Memorandum

RE: Equinox Townhomes – Plan Review Letter 07.21.2026

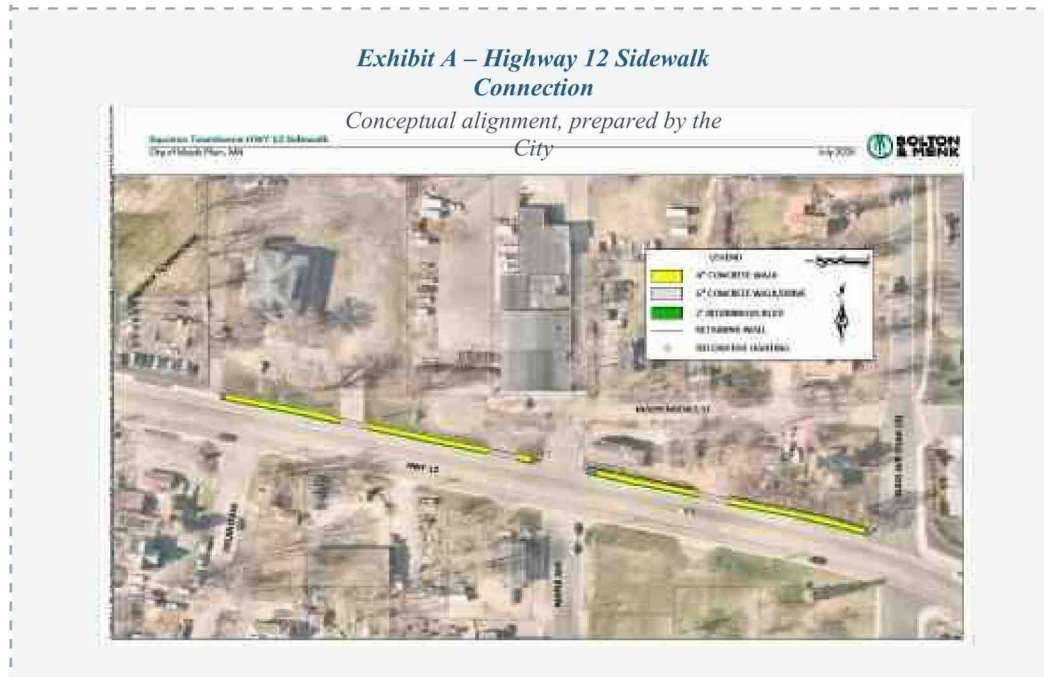
1. Highway 12 Sidewalk Connection

The City would like to see the sidewalk connection installed along Highway 12, consistent with prior discussions with your design team. The City has prepared an exhibit illustrating the potential connection alignment, along with an associated estimated construction cost, for your reference (see exhibit below).

Please revise the plan set to include this sidewalk connection. The City would also like to further discuss the parties' respective responsibilities for the design, construction, and cost of this improvement at the time of resubmittal.

Response: Per discussions with owners and City, this sidewalk will be shown on later versions of plans.

2. Sidewalk Alignment – Buildings C.1 and C.2

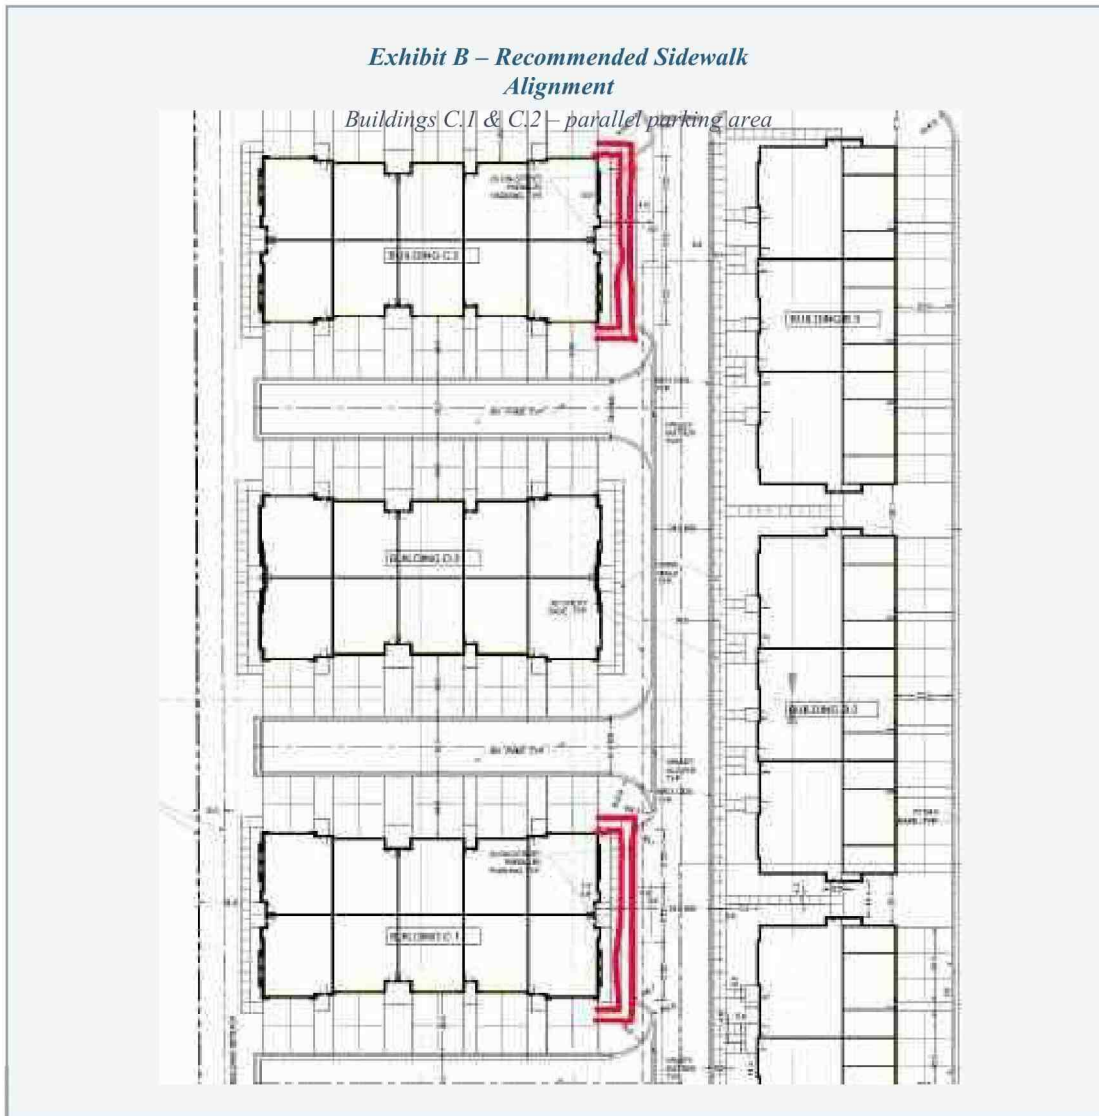
The sidewalk located along the east side of Buildings C.1 and C.2 does not align with the parallel parking spaces directly adjacent to it. Staff recommends shifting this sidewalk segment so that it abuts the parking spaces, allowing residents and guests to step directly from a parked vehicle onto the sidewalk rather than into the drive aisle (see

exhibit below).

CSG Response: Sidewalks updated.
